DOCKET 50-255 - LICENSE DPR-20 -
PALISADES PLANT - SEP TOPIC IX-5, VENTILATION SYSTEMS

PALISADES PLANT
SEP Topic IX-5, Ventilation Systems
Comments on NRC Topic Evaluation

FIGURE 1

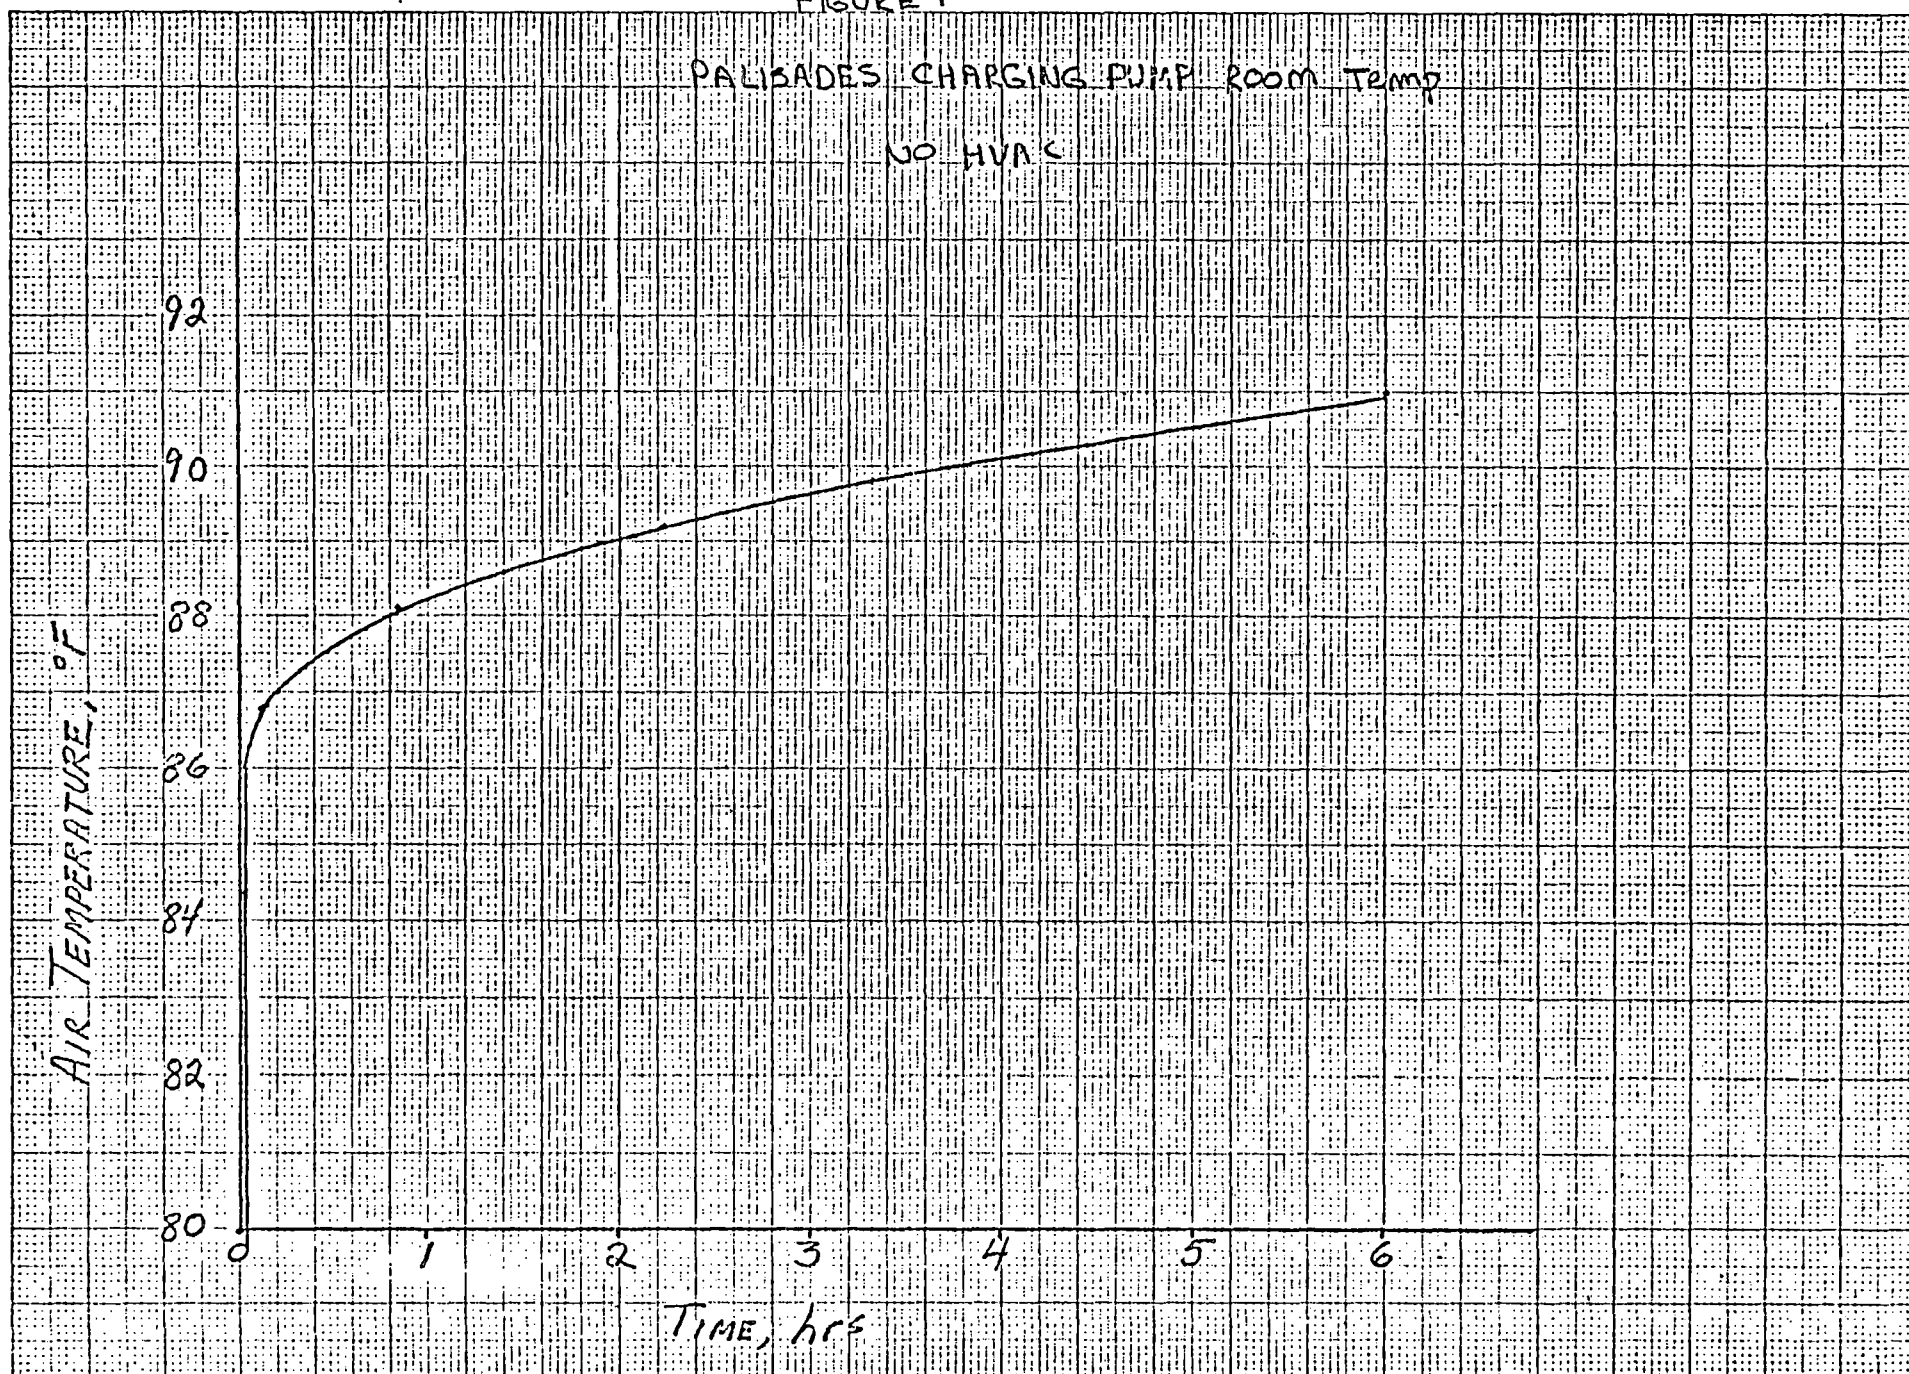
The loss of offsite power does have a higher probability of occurrence than loss of instrument air but loss of offsite power also trips the reactor and only activates the engineered safeguard equipment. Thus, there is a minimum of operating equipment to add heat. A simplified analysis was performed on the charging pump room assuming the three pump motors provide the heat input. The only other heat input would be that radiated from the insulated process lines carrying 120°F water. Since the normal design ambient for the pump and motor is also 120°F(5) the terminal temperature from this source is equal to the design temperature. Attachment 1 contains the input parameters and graphical output from the simplified analysis. This demonstrates less than an 11°F rise in 6 hours and a temperature rise of only 0.4°F during the fifth hour. Thus, assuming an initial temperature of 80°F it would take on the order of 83 hours to reach the design temperature of 120°F. This would allow ample time to restore normal power via back feed through the main transformer or to install temporary air movers.

The room air temperature following a loss of HVAC cooling was calculated for the charging pump room at Palisades. The calculation is contained in the above reference and the results are plotted in Figure 1. As shown, the temperature increases rapidly until the energy removal by the concrete in the room becomes significant. At that time the increase in temperature only slowly increases with time reaching only 91.0°F at the end of 6 hrs.

Fig. I

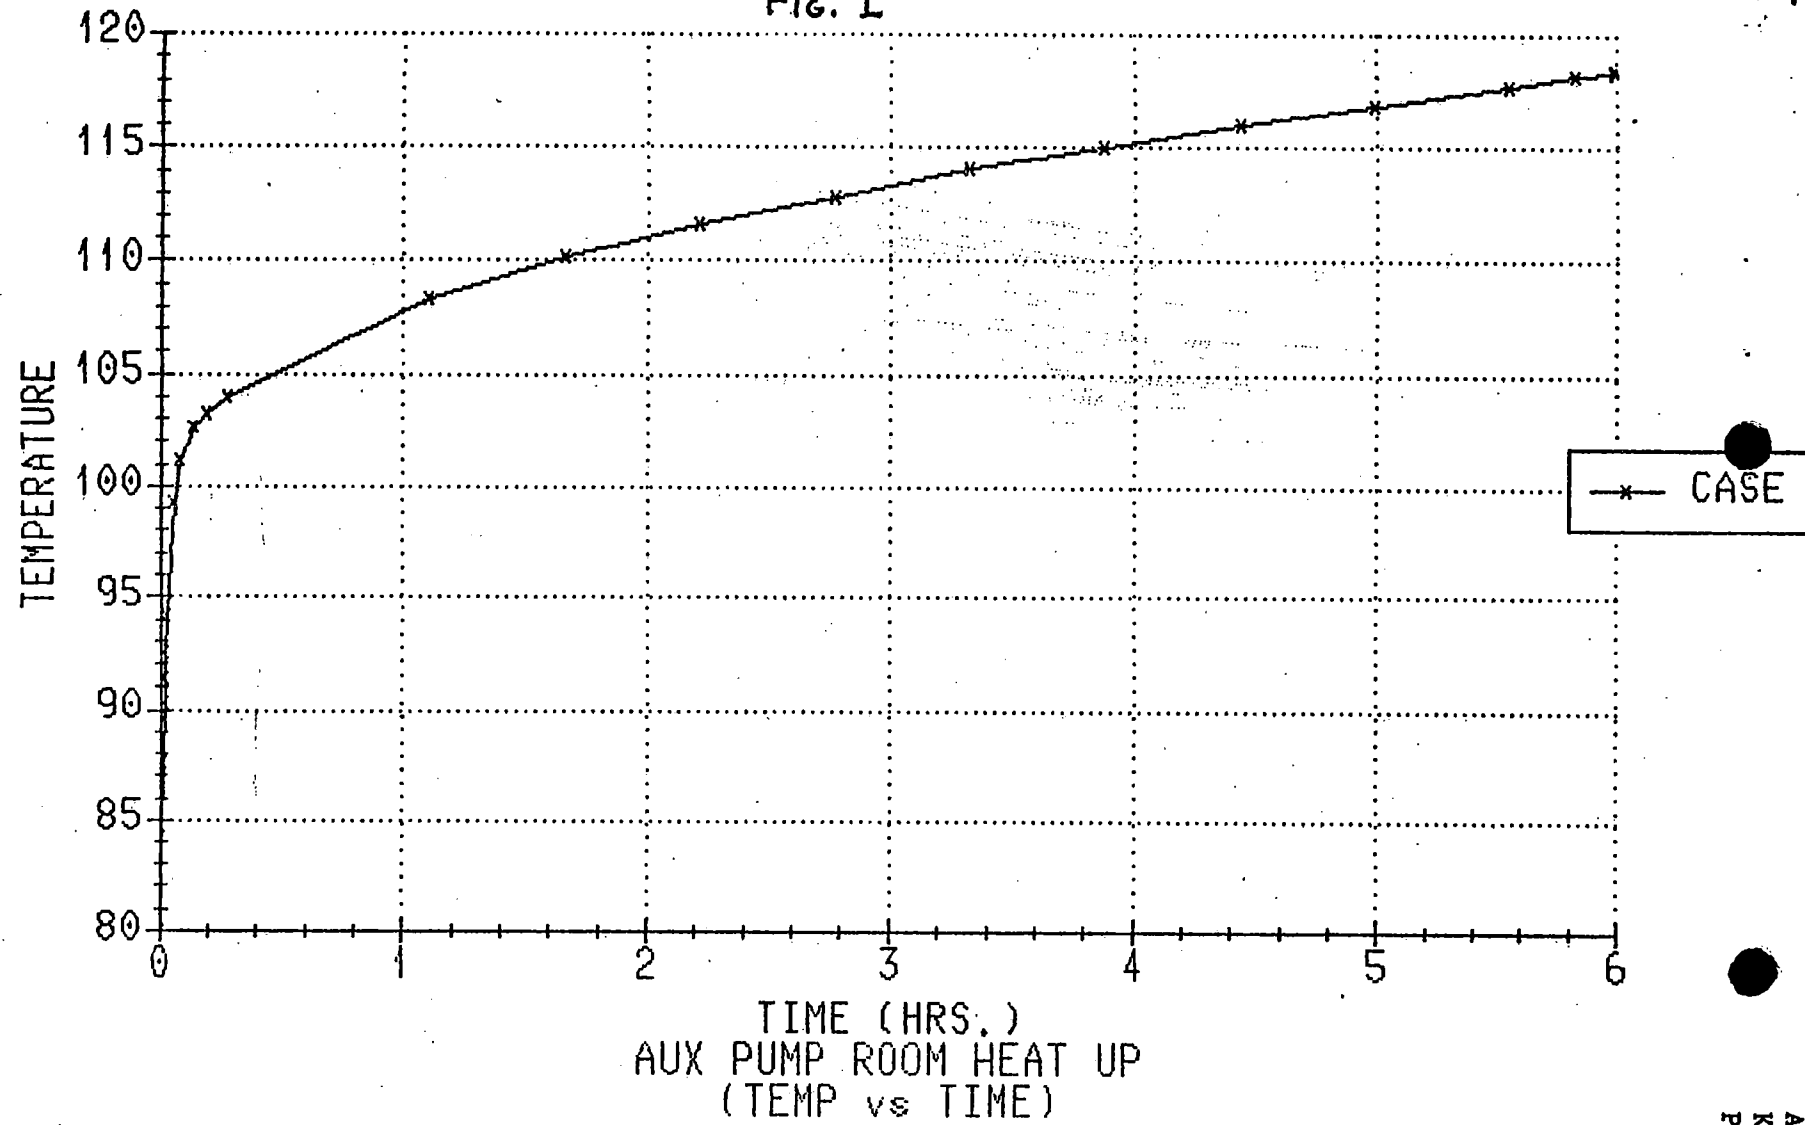
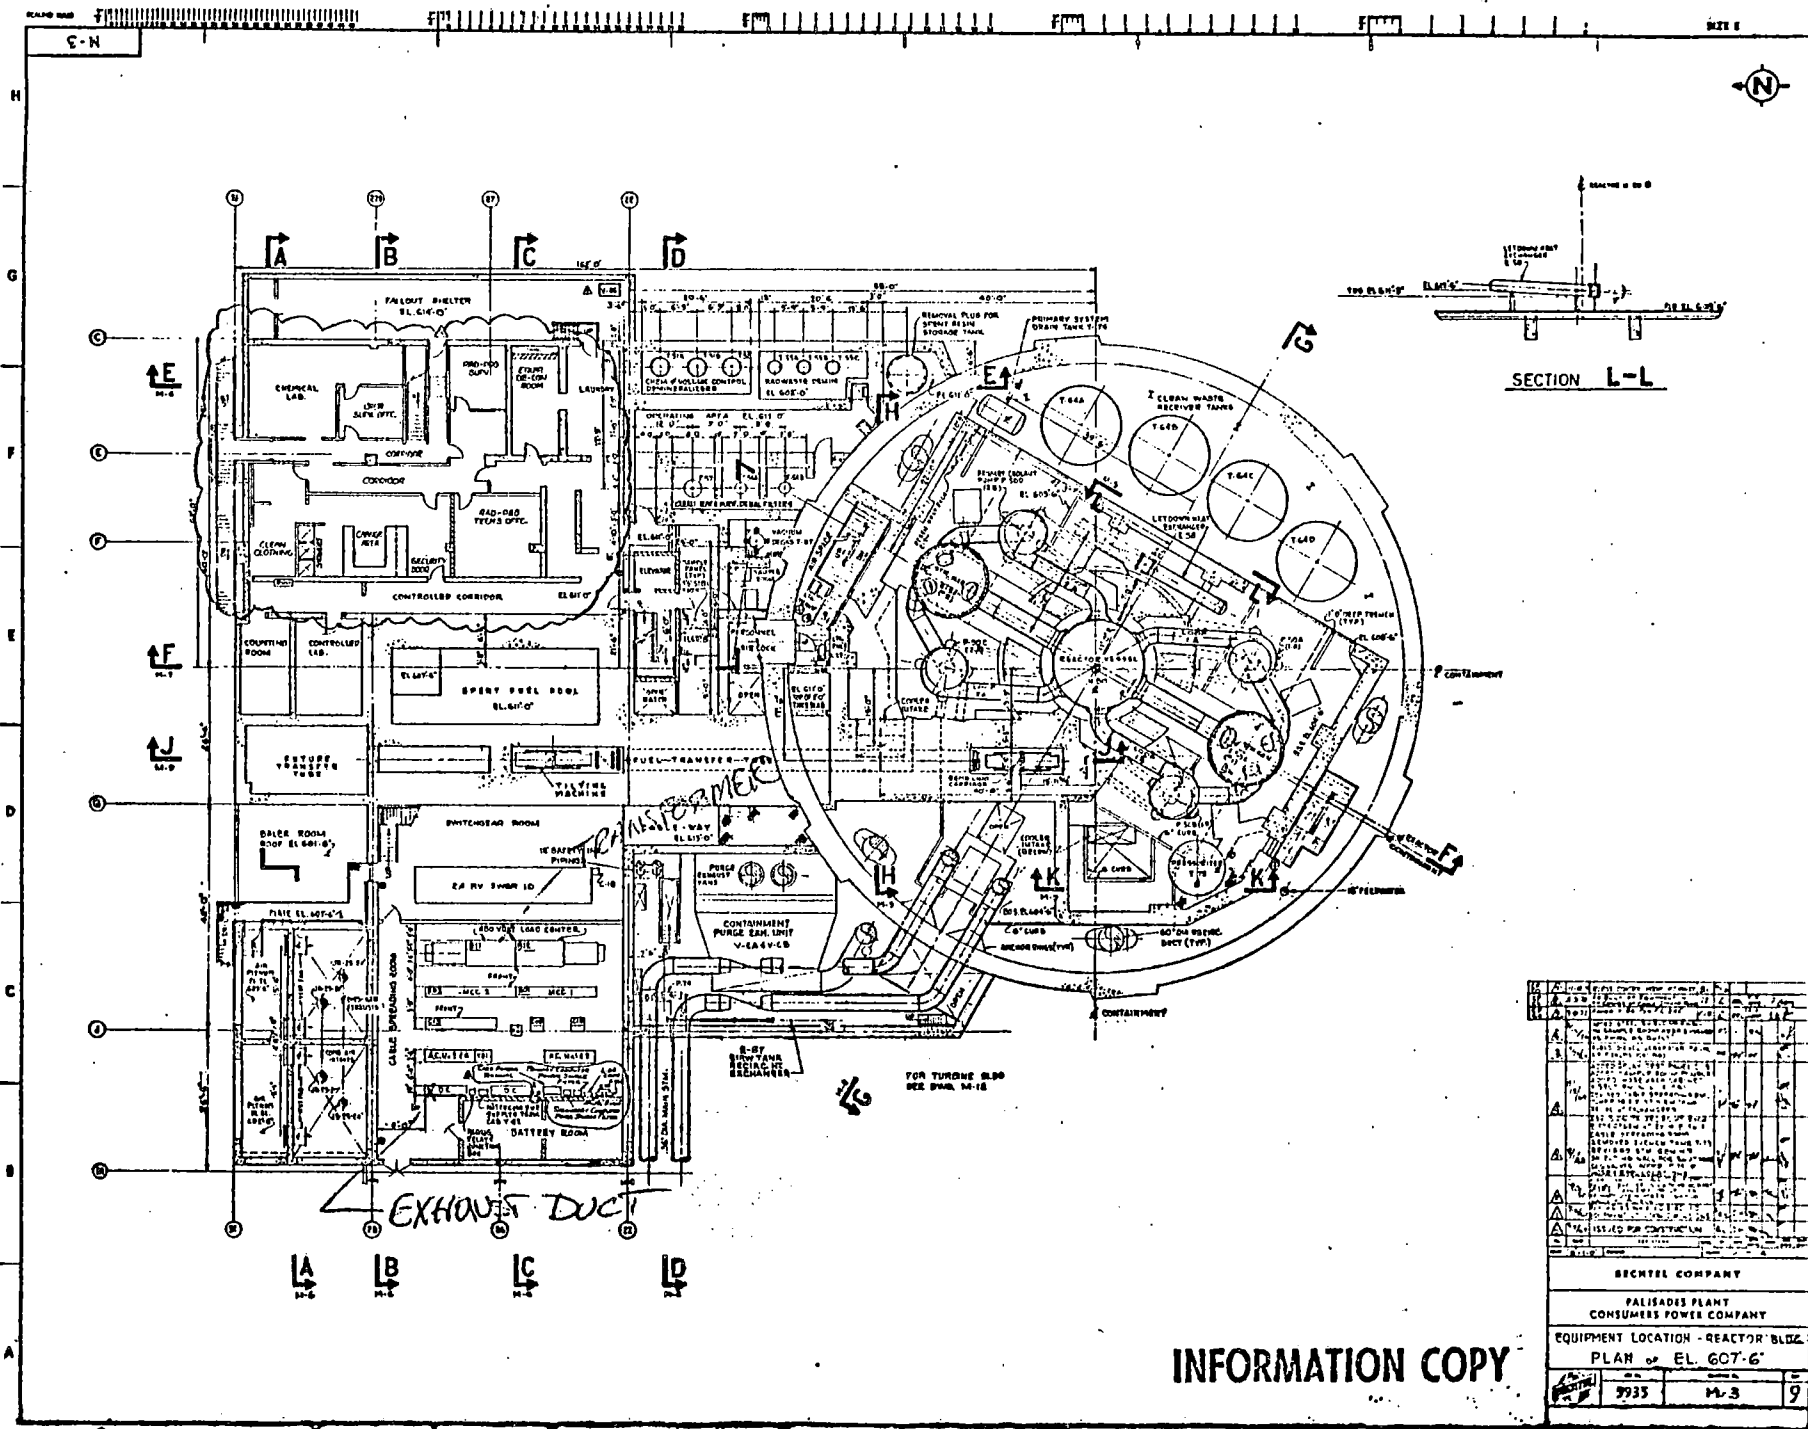
This pump room experienced the same 4 hour 34 minute power outage as the CVCS with the motor driven pump in operation. This demonstrates there is ample time to take corrective action in the event of loss of TAVS. This room was evaluated in a manner similar to the charging pump room (see Attachment 2). The majority of the pipes in this room are uninsulated and the process fluid is condensate storage tank water which has a normal operating range of 50°F to 80°F. Thus, this piping normally acts as a heat sink rather than a heat source. The analysis was run assuming only the motor driven pump was operating. This is the normal operating mode and this single pump has adequate capacity for all plant transients. If the steam driven pump were operated, room temperature would be increased considerably due to the uninsulated steam supply and exhaust piping. This could jeopardize parallel operation of these pumps since room temperature could exceed the design rating of the motor, but this high ambient should not affect the turbine driver nor either pump since it is pumping less than 80°F liquid. Since the capacity of either pump exceeds normal transient flow requirements, it is not anticipated that there would be sustained parallel operation. The analysis indicates a 38°F rise in 6 hours with a temperature rise of 1.5°F during the fifth hour. This room has two other mitigating design features which were not factored into the analysis. The ceiling is 20 feet high with all active components within 7 feet of the floor. Secondly, there is an 18-inch diameter, 5-foot tall chimney located in the ceiling. This chimney, the normal air discharge duct, has a 5-foot extension above the 590-foot elevation to protect the auxiliary feedwater pump room from flooding. These two features would provide a natural circulation of some quantity of air driven by convective forces.

The air temperature of the Auxiliary Feed Pump Room was calculated after a loss of HVAC cooling. The calculations are contained in the above reference and a plot of the results is shown in Fig. I. The rapid rise in temperature at the beginning of the problem is due to the fact that the heat sinks don't reach their full capacity right away. Once the sinks do begin to work effectively the rate of heat up is slowed to a much more steady pace for the remainder of the problem where it reaches 118°F.

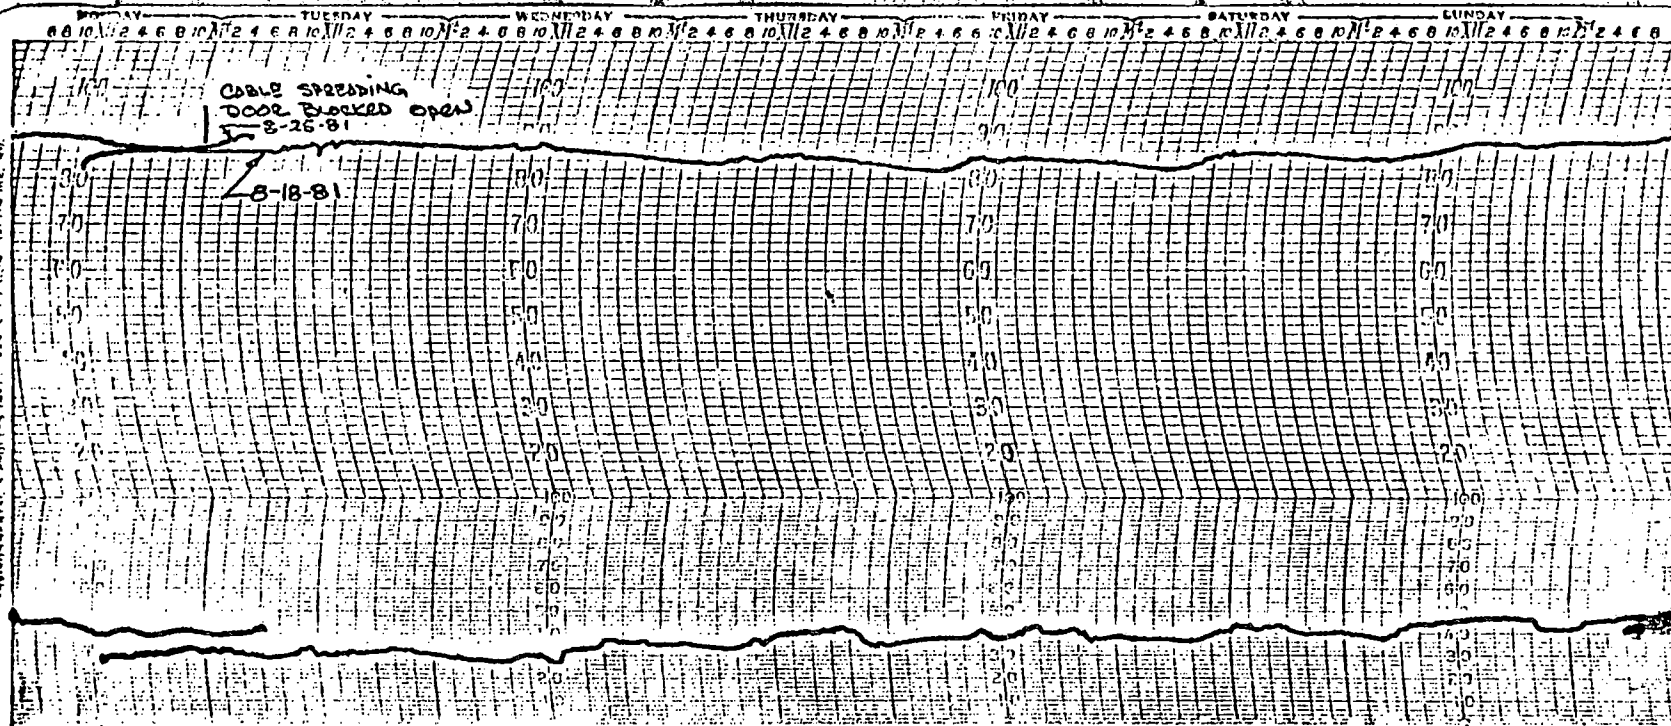
Data rejected due
to doors being blocked
open for outage
work. KJB

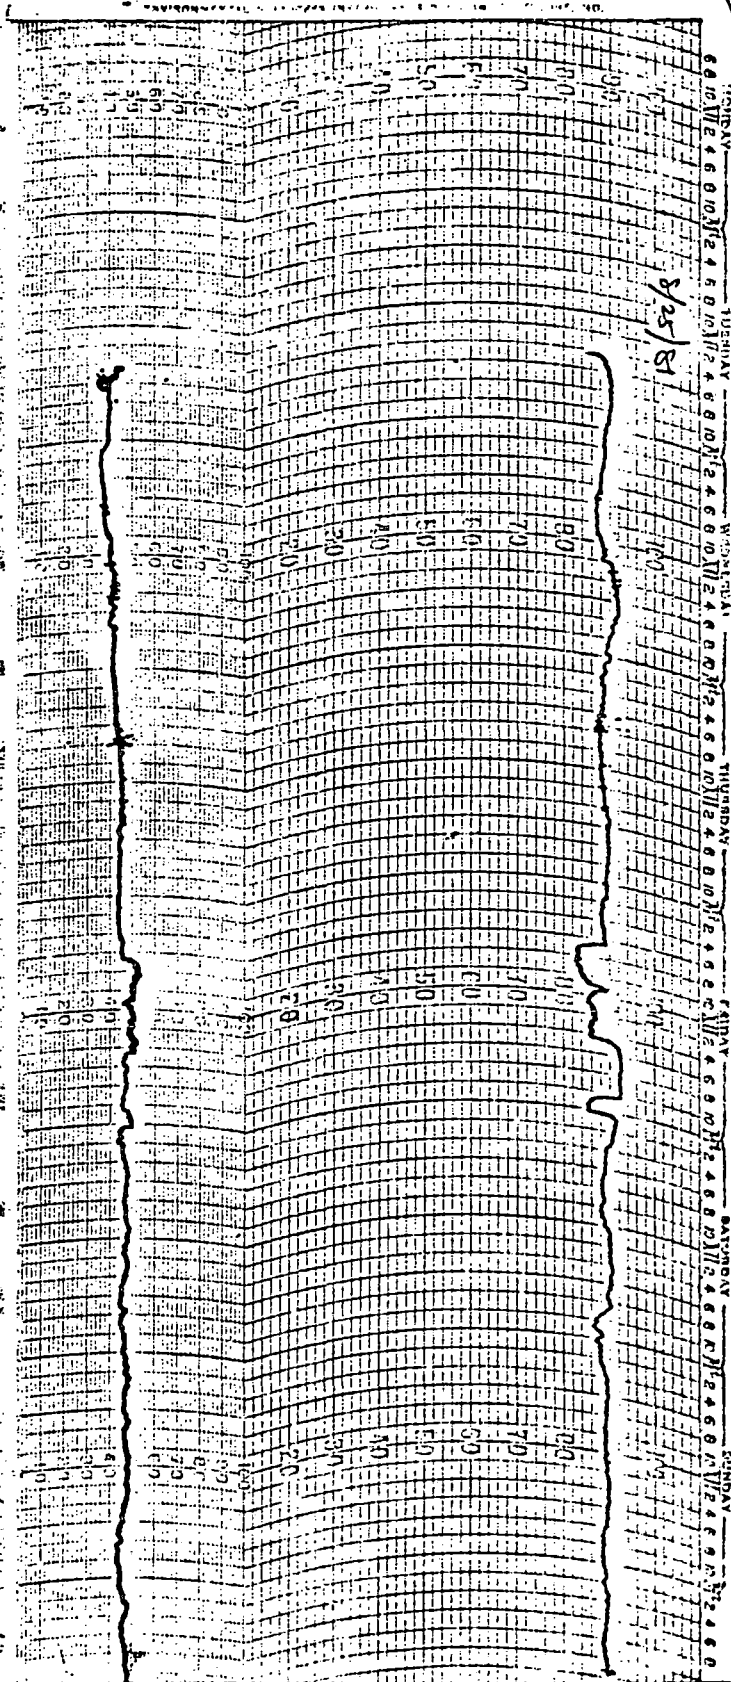
Date rejected due
to doors being blocked
open for outage work
KWB
